MODEL: iR2200/ 2800 / 3300

SUBJECT: Installing System Software V40.06

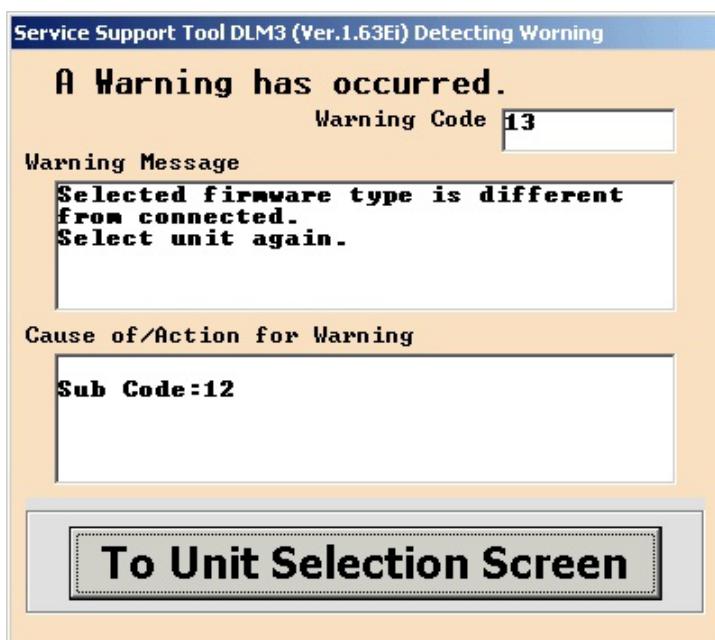
CD-ROM FY9-4082-016 contains file 'iR2200N-USen4006.ift' which causes an error. Due to this error it is impossible to use the system software on 'H' PCL only machines.

The following error is displayed when upgrading is attempted.

To overcome this, a new file has been released and is available to download from Notes / Intranet or Dealmynet in the Product Driver Database, under Patches.

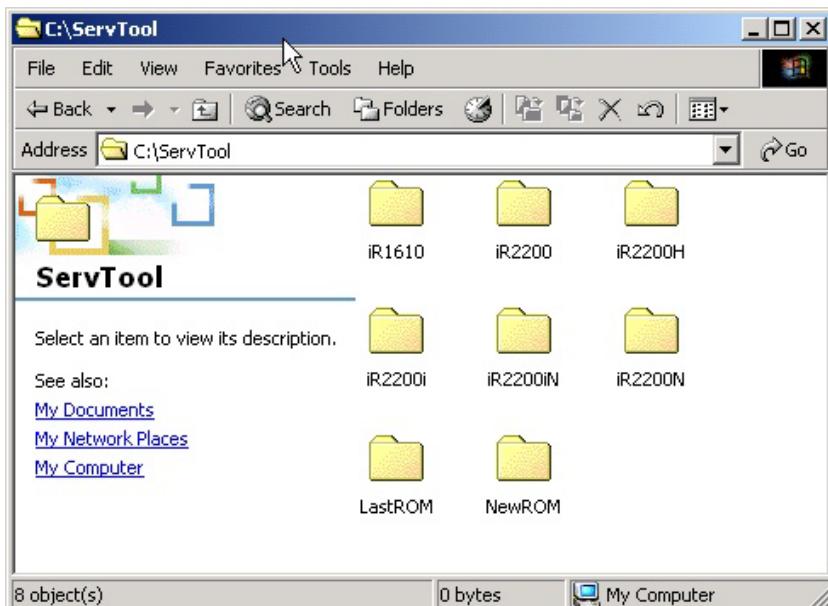
Locate the ServTool folder which was created when the SST was installed.

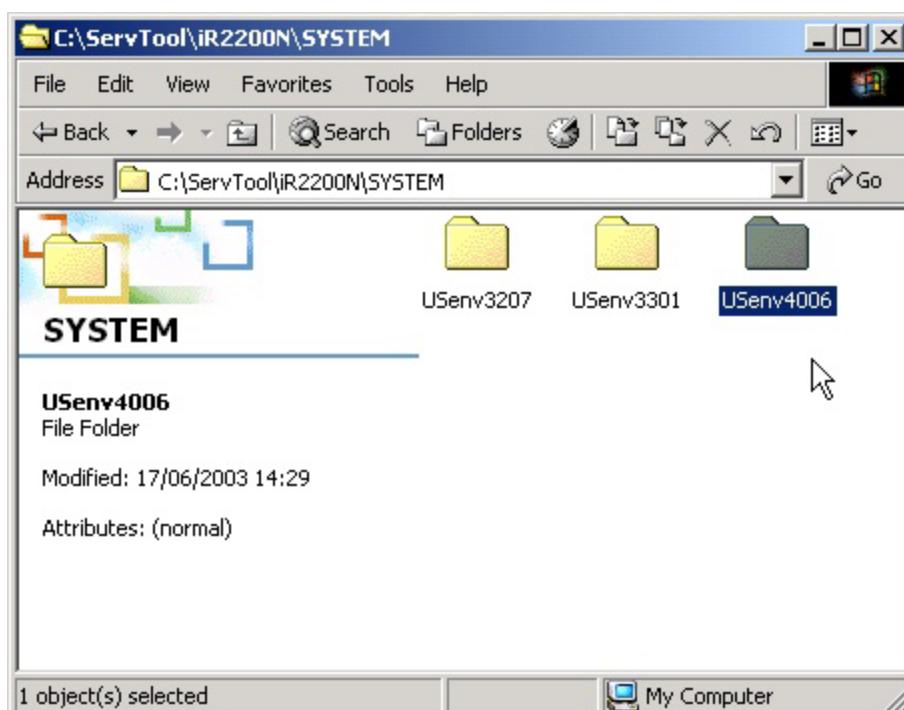
Open iR2200N Folder. Locate and open folder named "system". Within this folder you will find a folder named "USenv4006"

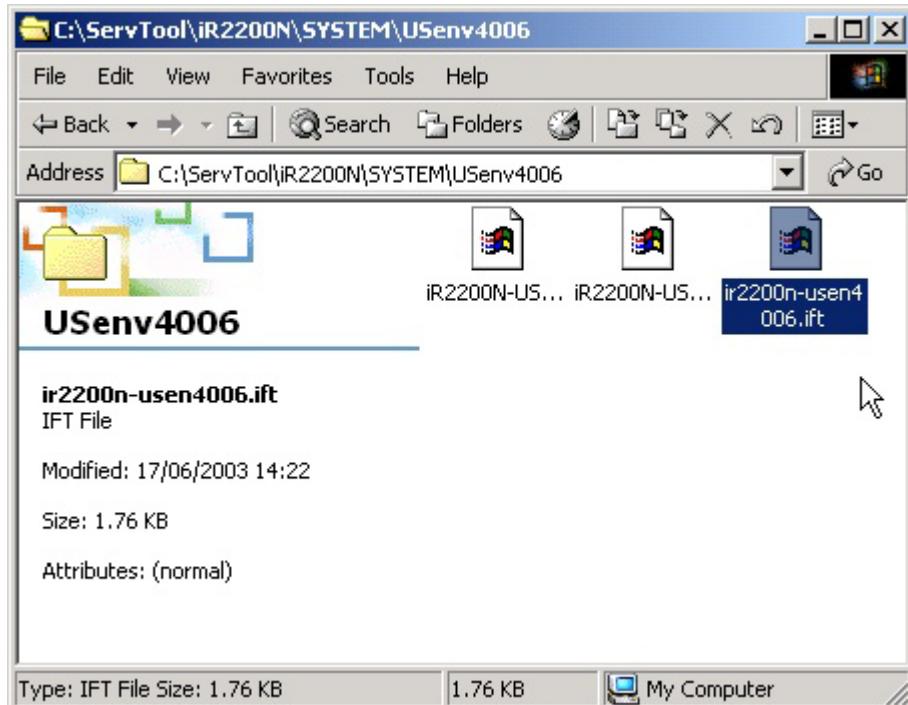
Open this folder and you will find a file named "ir2200n-usen4006.ift".

Delete this file and replace it with the revised file downloaded from Notes / Intranet or Dealernet.

Start SST and download V40.06
